Car Stereo Service Bulletin

Model: CDX-5060/5260/5460/U6260

No. 317

Subject: Buzz And/Or Clicks In Audio When Hand-Held Cellular Phone Is Used.

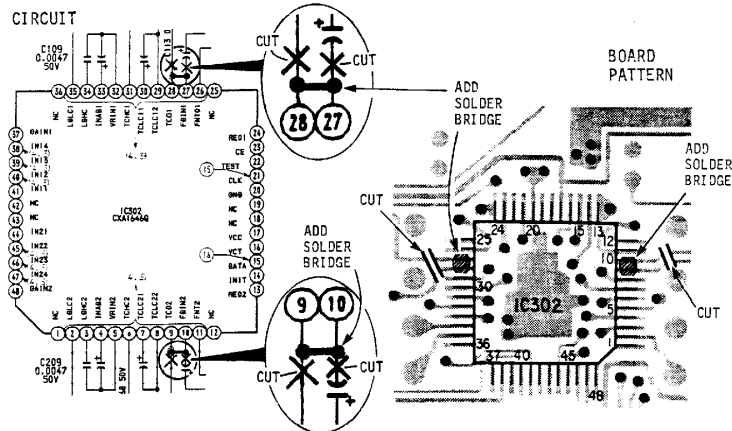
In some units, the customer may hear a buzz and/or clicks in the audio when the customer is using a hand-held cellular phone.

Solution: If the customer complains of this problem, implement the circuit changes shown below.

- 1- Cut the traces coming from IC302 pins 9 & 10, and pins 27 & 28.
- 2- Add a solder bridge between IC302 pins 9 & 10.
- 3- Add a solder bridge between IC302 pins 27 & 28.
